Body/Chassis – Water Leak From Roof Area

22-23MY Range Rover, 23MY Range Rover Sport SVR

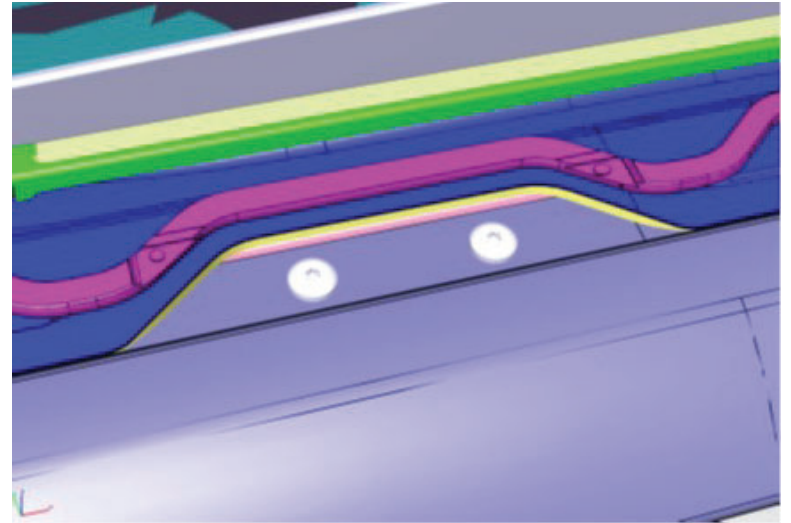
Seal this area

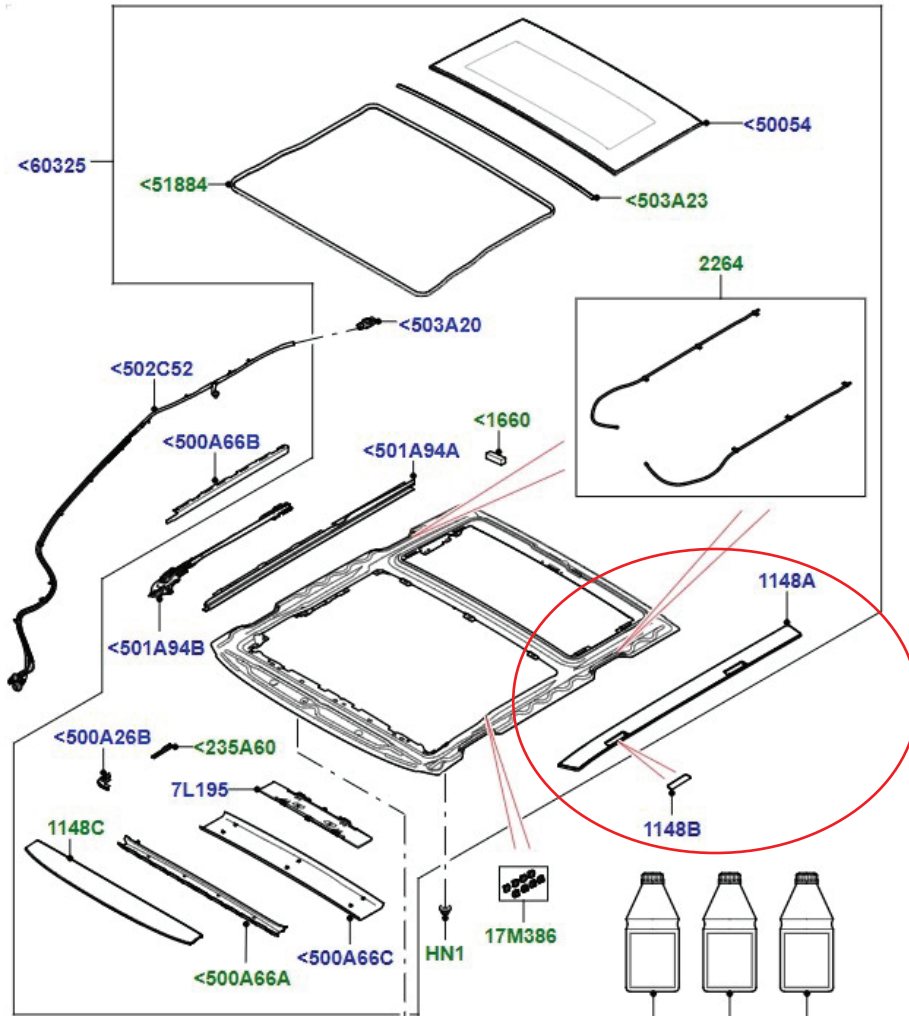
- The roof ditch trim is bonded in place.
- It needs to be cutout to be removed.
- Any gap in the roof opening panel cassette sealant can be resealed by removing just the trim panel.
